Reliability Analysis Update

Transmission Expansion Advisory
Committee
May 16, 2019

B2970 Project Update:

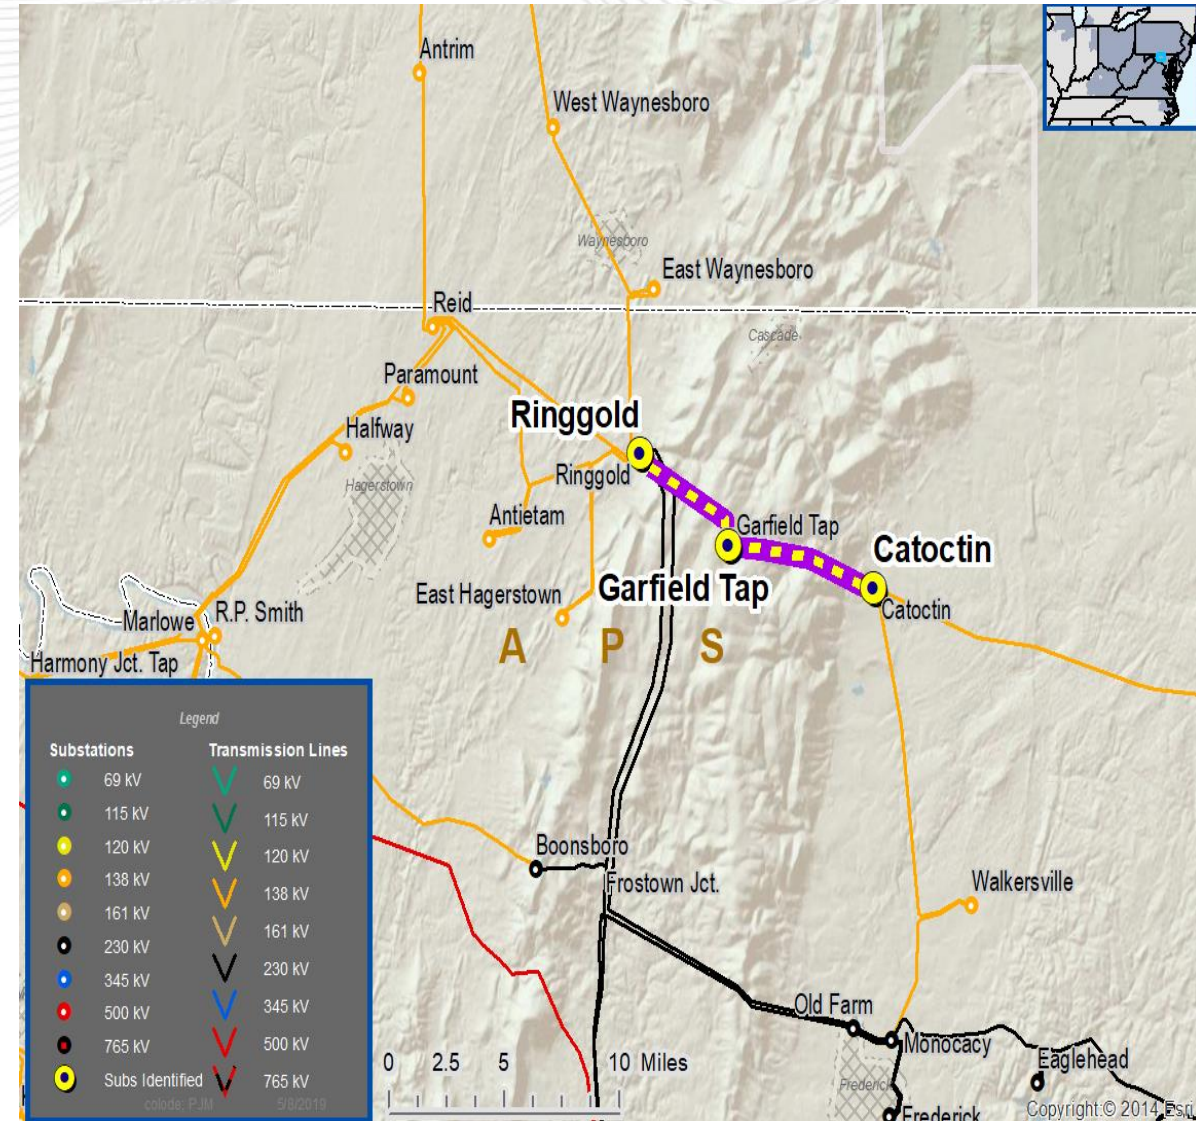
• There is a 138/12.5 kV station (Garfield) tapped on the Ring Gold – Catoctin 138 kV circuit that should be converted to 230 kV as part of the B2970 project, but was missed from the original scope and cost estimate. Update the scope of the B2970 to reflect the additional work needed to convert the Garfield 138/12.5 kV to 230/12.5 kV.

• **B2970.5** → Convert Garfield 138/12.5 kV substation to 230/12.5 kV.

Estimated Project Cost: \$ 2.2 M

Total Estimated Project Cost: \$15.53 M

Dominion Transmission Zone: Baseline NIVO 230kV Breaker "2116T2130" Replacement

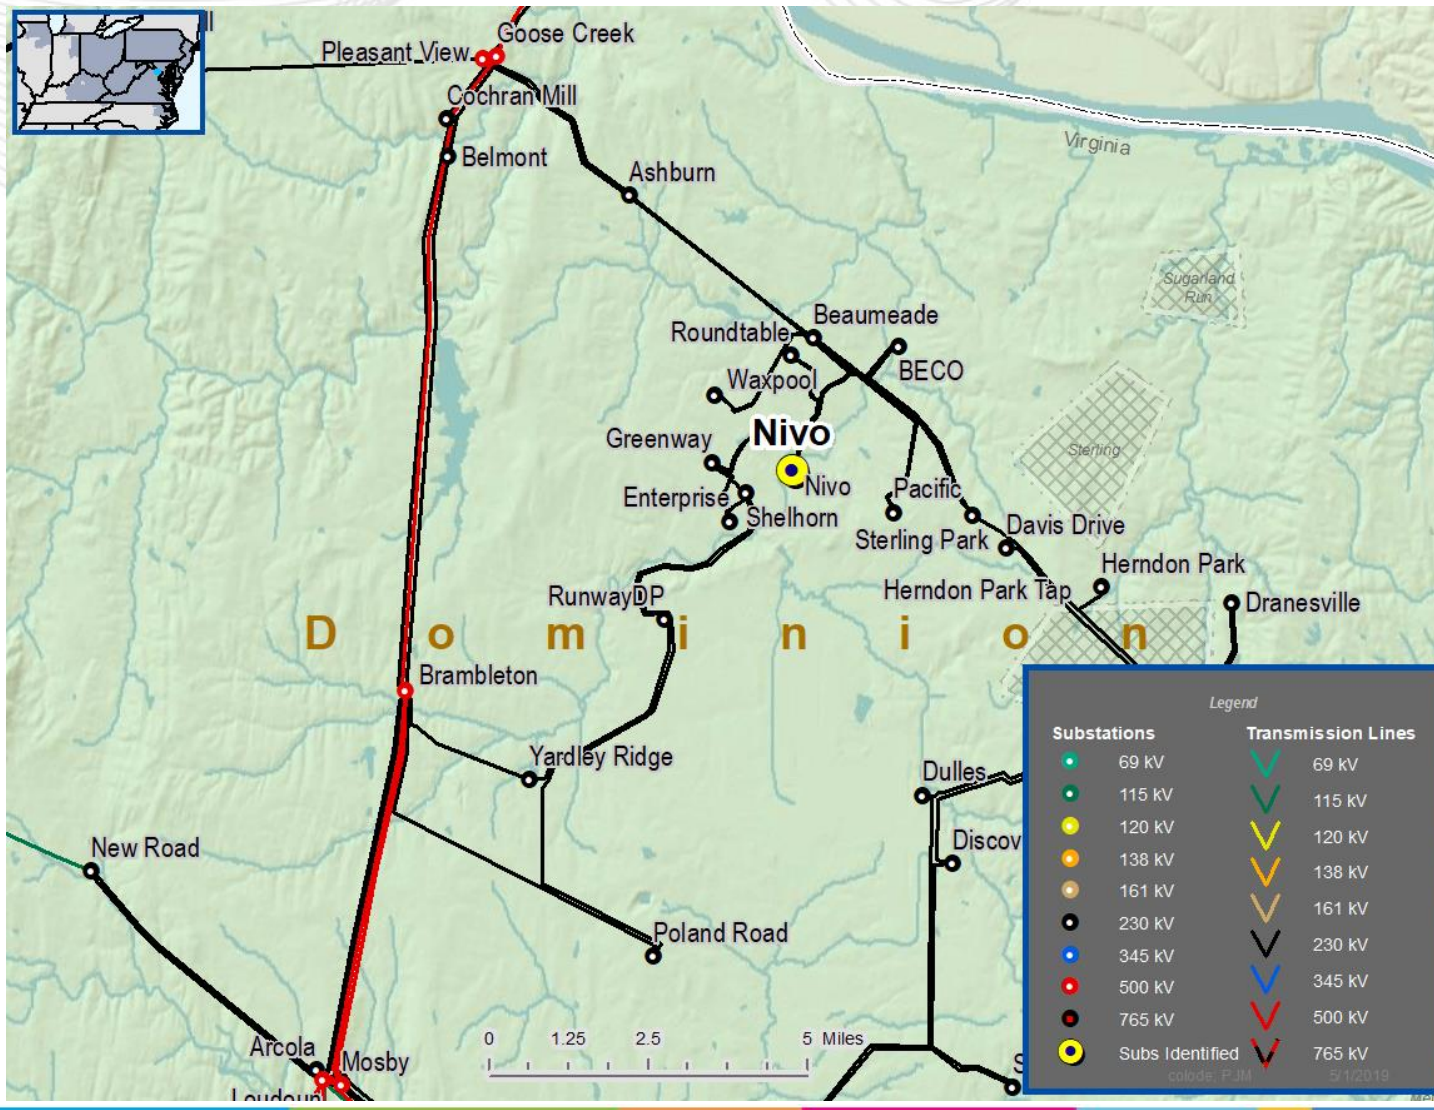
Existing b2962.2 Date Change
Date Project Last Presented: 06/07/2018

Problem Statement: Short Circuit
• The NIVO 230kV breaker "2116T2130" is overdutied.

Previous Required In-service Date: 6/1/2022
Revised In-service Date: 6/1/2021
